Bill No. 10-135

TITLE: **CHANGE OF ZONE NO. 10018, NEBRASKA INNOVATION CAMPUS (NIC) PLANNED UNIT DEVELOPMENT,** from P Public Use District to O-3 Office Park District PUD, requested by the University of Nebraska-Lincoln, on property adjacent to the University of Nebraska-Lincoln city campus and including the former Nebraska State Fair Park.

LINCOLN/LANCASTER COUNTY PLANNING STAFF REPORT

PROJECT #: Change of Zone No.10018 Innovation Campus Planned Unit Development (PUD)

0 1" 2"
FILENAME: PLAT-SITEPLAN.dwg
SCALE: 1" = 200'-0"
SHEET 3 OF 22

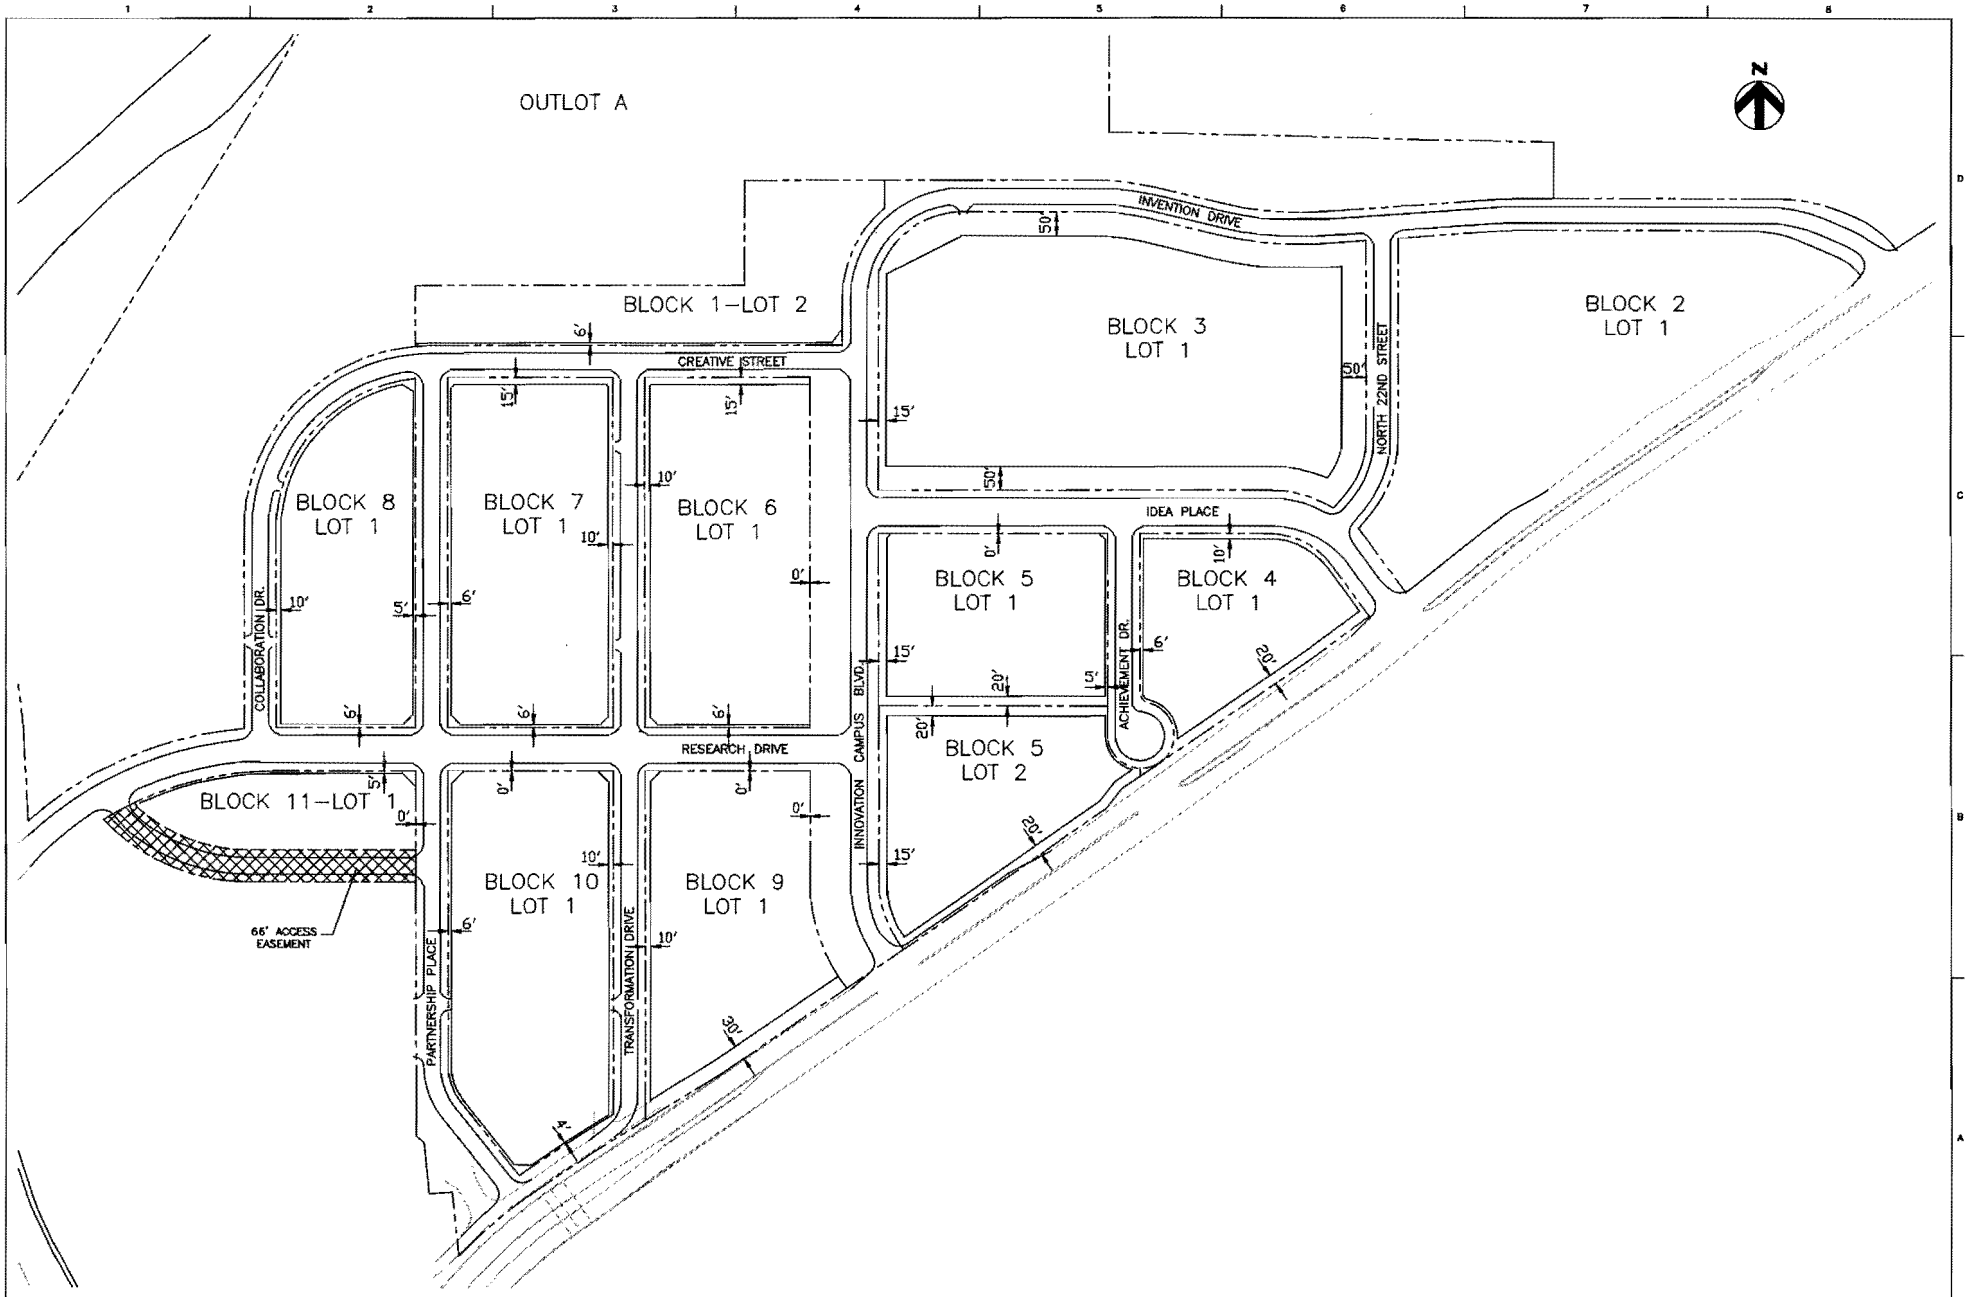
1.4 Eliminate the land use table from Sheet 3.

1.6 Combine Sheet 22-Setback with Sheet 3-Site Plan to reduce the number of sheets and provide clarity on setbacks and ROW widths.

1.10 Identify the purpose of Outlot A on Sheet 3.

1.11 Add “public” before access at the 66" access easement on Sheet 3.
